Public Service Electric and Gas Company P.O. Box 236 Hancocks Bridge, New Jersey 08038-0236

LRN-00-0146 LCR S99-19

SUPPLEMENTAL INFORMATION FOR RADIOACTIVE EFFLUENT TECHNICAL SPECIFICATION CHANGE REQUEST, SALEM GENERATING STATION UNIT NOS. 1 AND 2 FACILITY OPERATING LICENSES DPR-70 AND DPR-75 DOCKET NOS. 50-272 AND 50-311

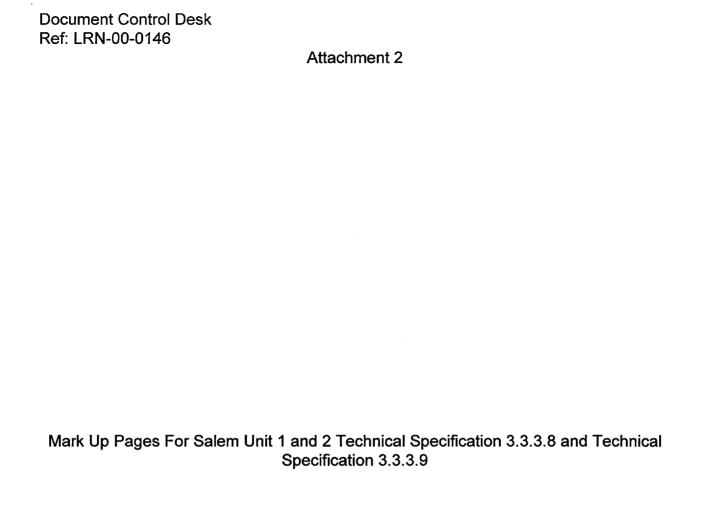
For changes to the Bases for Specification 3/4.3.3.9 of the TS, the markup for Unit 1 shows text being deleted in the paragraph whereas the markup for Unit 2 does not show the same text being deleted. Why is this?

The correct mark-up page for Salem Unit 2 TS Bases 3/4.3.3.9, has been provided in a separate supplement (PSE&G letter LRN-00-109, dated April 19, 2000).
